Invitation to Tender (ITT)

Laboratory Centre for Disease Control (LCDC) Fire Alarm Replacement Project- 100 Eglantine Driveway

ANNEX I – QUESTIONS AND ANSWERS

DRAWING
**GENERAL NOTES & EXISTING
DEVICE COUNTS**

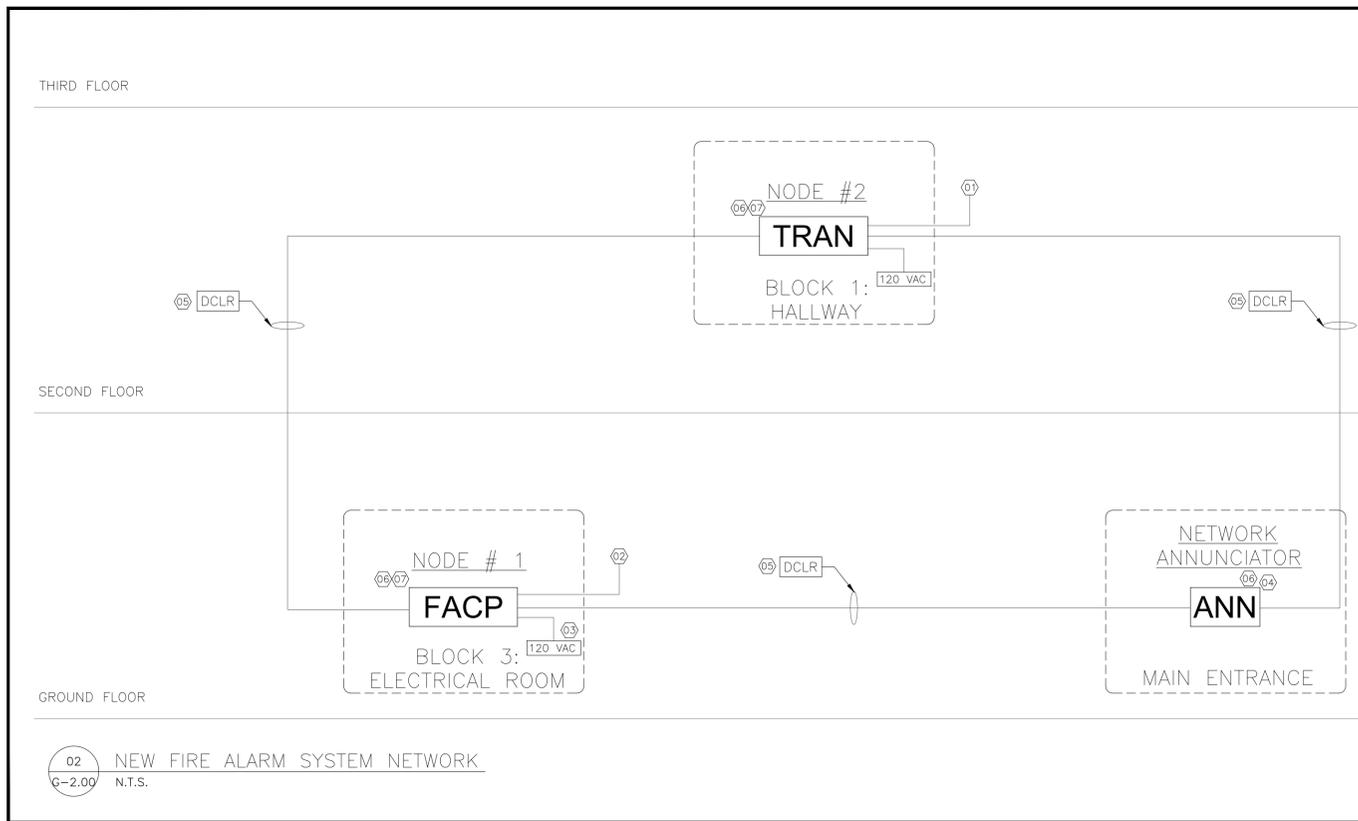
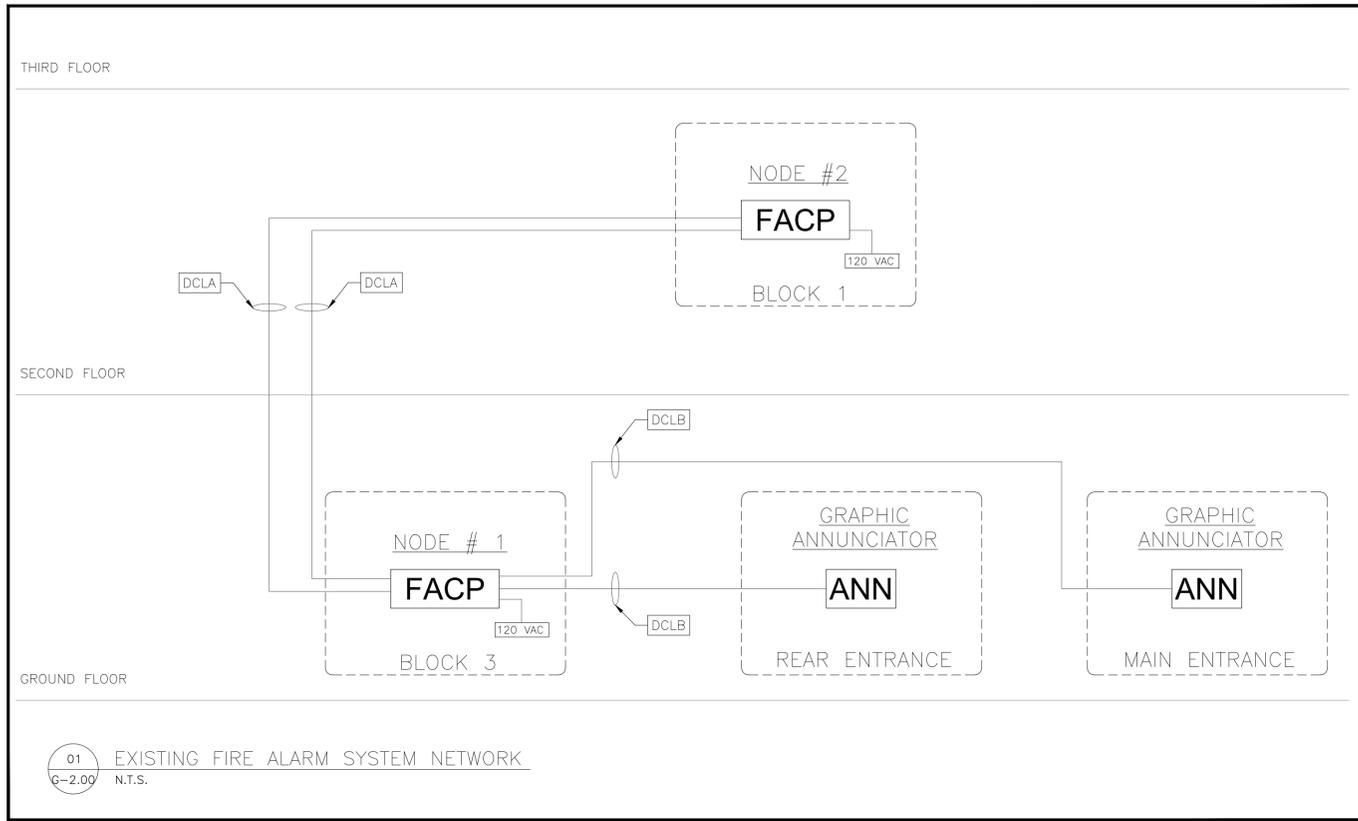
On drawing G1.0 existing device counts, are we replacing all of these & adding all the new fire alarm pull stations & smoke detectors? Please confirm.

From drawing G1.0. All detection and control devices are being replaced and all signalling devices are being retained. Please refer to Items 1.10 to 1.17.
